Dantzic - Methodology for moving Federation gas main

Russells Construction

Photograph of sub-basement entry point

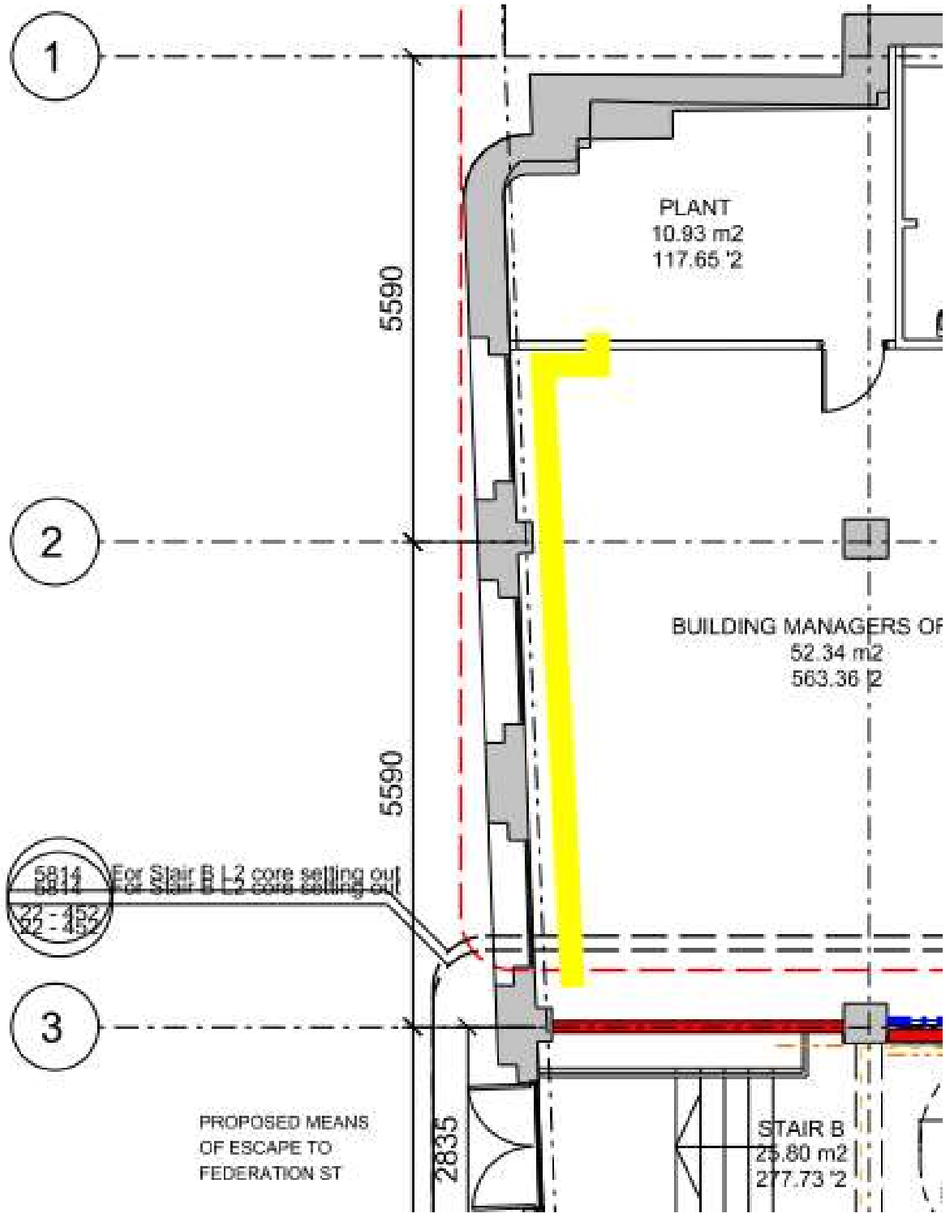
Diversion of gas main -
Following a meeting with ENW, the gas main in the Dantzic sub-basement will need to be moved to accomodate the incoming electric supply. ENW require a 300mm service free zone around their cables, which we currently do not comply with. It is proposed that the gas main will be diverted from the flange at GL3 and penertrate through the basement slab. The pipe will then run at low level at the back of the building managers office and into the gas plant room. This will be boxed in and vented. The drainage pipe that also runs through the HV substation will also need to be boxed out to maintain access to this.
